#### PLANNING COMMISSION MEETING AGENDA REGULAR MEETING

<u>SPECIAL USE APPROVAL AND PRELIMINARY SITE PLAN REVIEW (SU JPLN2023-0019)</u> - Proposed Clean Express Car Wash, West side of John R, North of Fourteen Mile (PIN 88-20-35-401-001), Section 35, Zoned GB (General Business) District

PRELIMINARY SITE PLAN REVIEW (File Number SP JPLN2023-0026) – Proposed Controlled Exit onto Colebrook from Parking Lot, Northwest corner of Rochester and Colebrook (3635 Rochester; PIN 88-20-22-276-051, -052 & -053), Section 22, Currently Zoned GB (General Business) and R-1C (One Family Residential) District

## Preliminary Site Plan For City of Troy, Michigan

A landscaping plan has been provided on Sheet L101. The following table discusses the development's compliance with the landscape requirements set forth in Section 13.02.

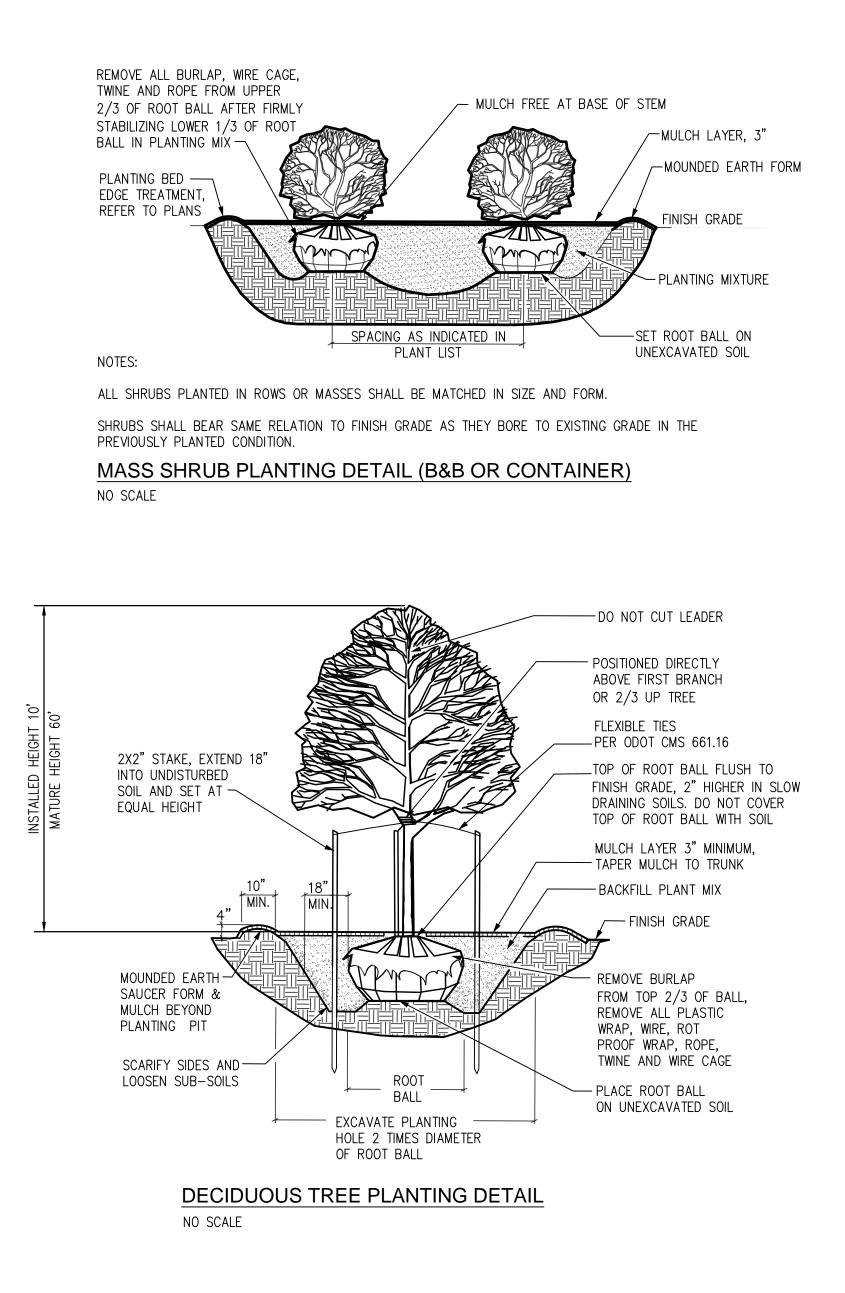
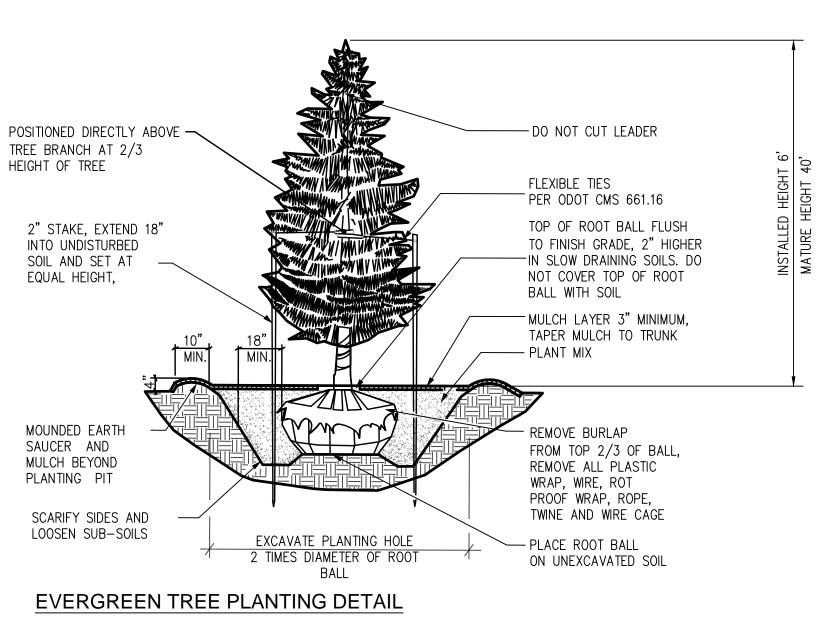
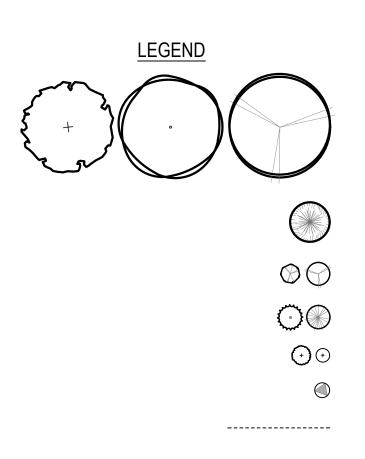
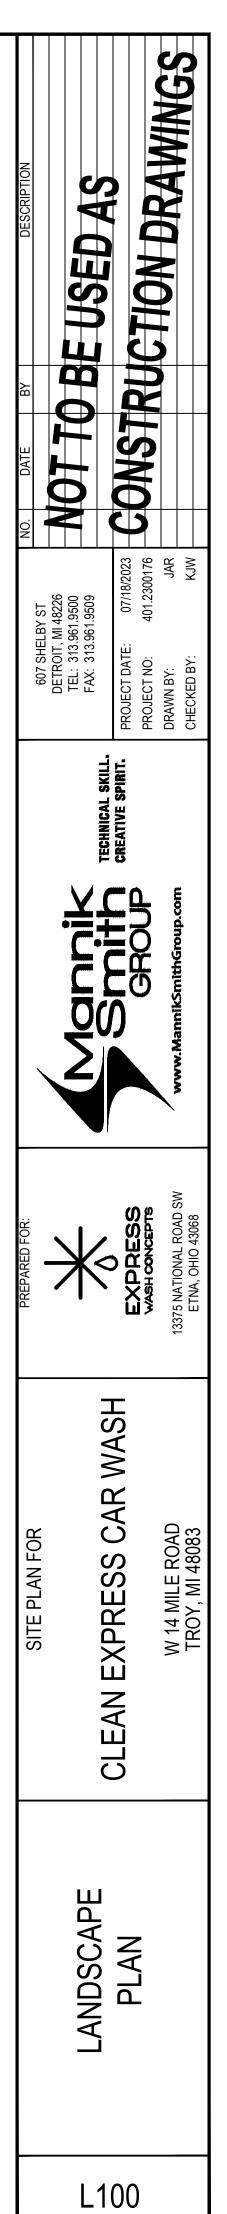
We note that there is a long stretch of parking (with vacuums) that does not have any parking lot landscaping. We had recommended that the applicant provide two (2) parking lot trees internal to the parking lot along the western parking area, and one (1) tree along the eastern parking lot area. Parking lot trees in the western parking area will also breakup and help distinguish and define the property and use boundaries of the carwash. The applicant added one (1) parking lot tree along the western parking lot area. Landscape Plan was not stamped by a licensed landscape architect.

**Items to be Addressed**: 1). Add one (1) parking lot tree internal to the parking lot along the western parking area, and one (1) tree along the eastern parking lot area; and 2). Stamp plan by licensed landscape architect.

- 1. Add one (1) parking lot tree internal to the parking lot along the western parking area, and one (1) tree along the eastern parking lot area.
- 2. Stamp plan by licensed landscape architect.

These are photos taken from the site of the partially completed work.

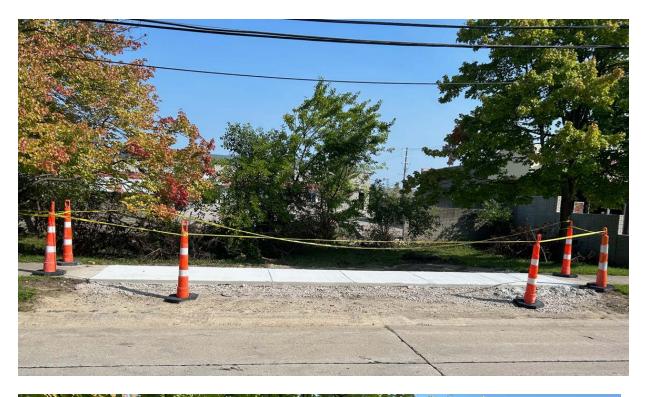
The applicant is seeking approval to construct a curb cut and drive-aisle to Colebrook through an existing parking lot. The use of the site is for religious services for a place of worship. The applicant notes that during busy times, particularly Friday afternoons, it is difficult to exit the site directly onto Livernois.
